**DECISION DOCUMENT**

**NYC VCP and E-Designation Remedial Action Work Plan Approval**

Re: 86 Fleet Place  
Brooklyn Block 2061, Lot 50  
Hazardous Materials and Noise “E” Designation  
E-241: Downtown Brooklyn Rezoning - CEQR 03DME016K  
OER Project Number 14EH-N496K / VCP Number 15CVCP014K

Wausau 4250i, section detail:

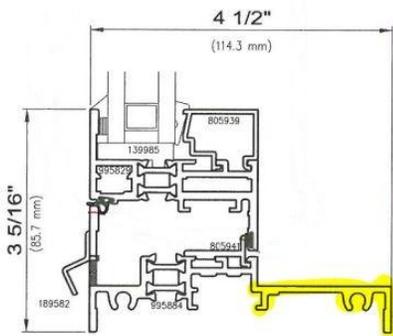
The acoustical reports described above are representative of the acoustical performance of all proposed windows/doors/curtain walls. Please note that a test report for the Fixed 4250i window is not available. However, Wausau has provided a test report for the Fixed 2250i, which is of identical construction with regard to the parts of the frame that support and seal to the glass. See details below:

The project acoustical engineer, Kristin Bleedorn, PE (83282PE, State of Oregon) certifies, in accordance with the applicable standard of care, that the acoustical performance of the Wausau 2250i and 4250i are expected to be equivalent; therefore, the Fixed 2250i test report stating an OITC rating of 28 should be considered an acceptable substitute for the unavailable Fixed 4450i report. In addition, the 2250i fixed window will have the same frame, gaskets, and glazing as the 2250i casement window which has an OITC rating of 28 dB(A). The fixed window is expected to perform at the same OITC rating as the casement.
